Access Compliance Report Public Rights-of-Way (Curb Ramps)

Main Street: STATION_WAY Cross Street: ANTONIO_PKWY Location: SE

ADA ID: RPRK211116113224 Ramp Type: Type 1 - Perpendicular Diagonal Initial Pass/Fail: Pass Overall Compliance: No Severity Score: 20

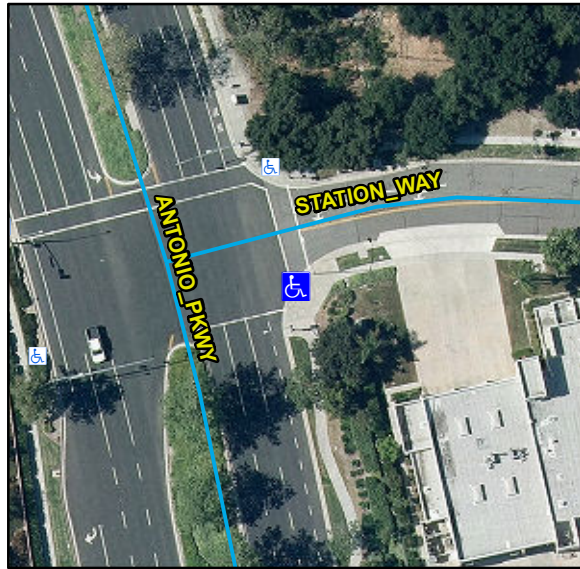
Compliance	Description	Data	Compliance	Description	Data
N/A	Ramp Length (in)	48	N/A	Flare Type LT	
Yes	Ramp Width (in)	124			Sloped
Yes	Ramp Run Slope (%)	5.8	Yes	Flare Slope LT (%)	7.7
Yes	Ramp Cross Slope (%)	1	N/A	Flare Traversable LT	Yes
N/A	Landing Present	Yes	N/A	Flare Type RT	
N/A	Landing Length (in)	41			Sloped
Yes	Landing Width (in)	48	Yes	Flare Slope RT (%)	7.3
No	Landing Run Slope (%)	3.2	N/A	Flare Traversable RT	Yes
Yes	Landing Cross Slope (%)	1.5	No	DWS Provided	No
N/A	Landing Movement Obstructed?	No	N/A	DWS Contrast	N/A
	Landing Movement Type	N/A	N/A	DWS Length (in)	N/A
N/A	Landing Shared	No	N/A	DWS Full Width	N/A
N/A	Clear Space	Yes	N/A	DWS Offset Left (in)	N/A
N/A	Clear Space To Crosswalk (in)	48	N/A	DWS Offset Right (in)	N/A
N/A	Marked Crosswalk 1	Yes	N/A	Marked Crosswalk 2	No
	Crossing 1 Direction	N		Crossing 2 Direction	W
	Marked Crosswalk 1 Width (in)	144		Marked Crosswalk 2 Width (in)	N/A

Yes	Ramp Inside Crosswalk 1	Yes	Yes	Ramp Inside Crosswalk 2	N/A
	Crossing 1 Slope (%)	3.4		Crossing 2 Slope (%)	1.9
	Crossing 1 Cross Slope (%)	0.1		Crossing 2 Cross Slope (%)	1.2
Yes	Gutter Ponding	No	No	Curb Slope	11.4
Yes	Gutter Lip Height (in)	0		Road Run Slope (%)	2
No	Gutter Run Slope (%)	11.2		Road Cross Slope (%)	0.5
No	Gutter Cross Slope (%)	2.3			
Yes	Overall Surface Condition: Acceptable		Yes	Perp Joint Present	Yes
	Cross Gutter Present?	No		Spandrel Present?	No
	Replace Cross Gutter?	N/A		Replace Spandrel?	N/A

Remove & Replace Curb Ramp With Two New Directional Ramps or Equivalent. Remove & Replace Gutter.
